**HAY CREEK VALLEY**  
**FINAL DRAINAGE REPORT**

December 2023

Project No. 22.886.076

PCD File SF2324

# Stormwater Detention and Infiltration Design Data Sheet

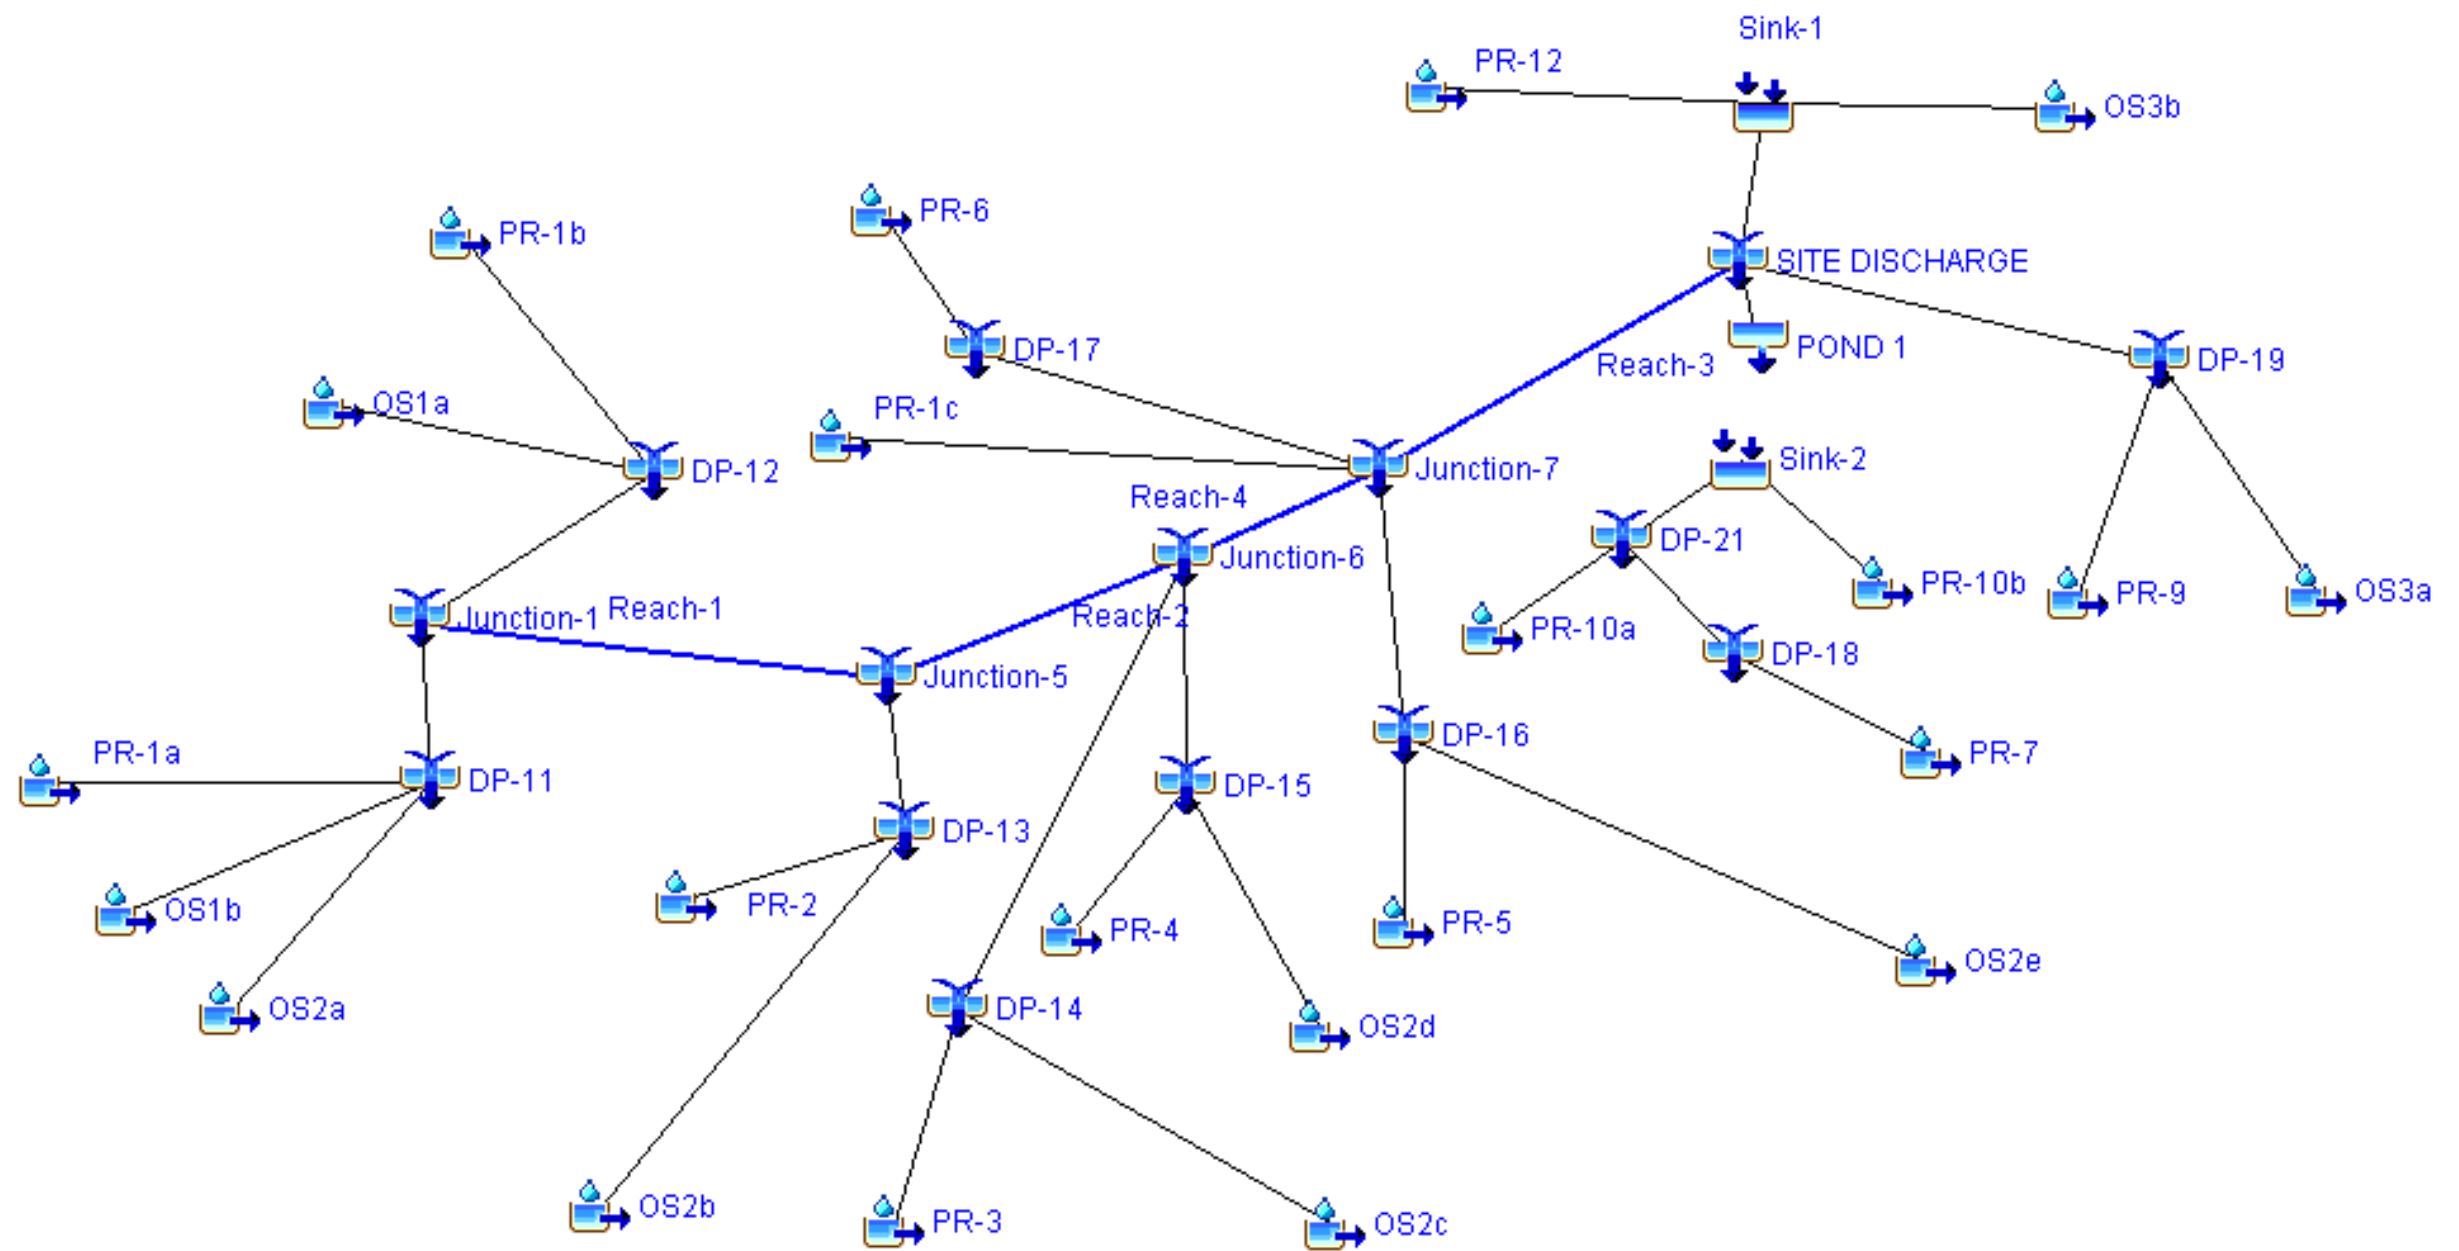
According to the table on the last page of this FDR, this UIA area should be 0.85ac or 37,026ac. Revise to remove discrepancy.
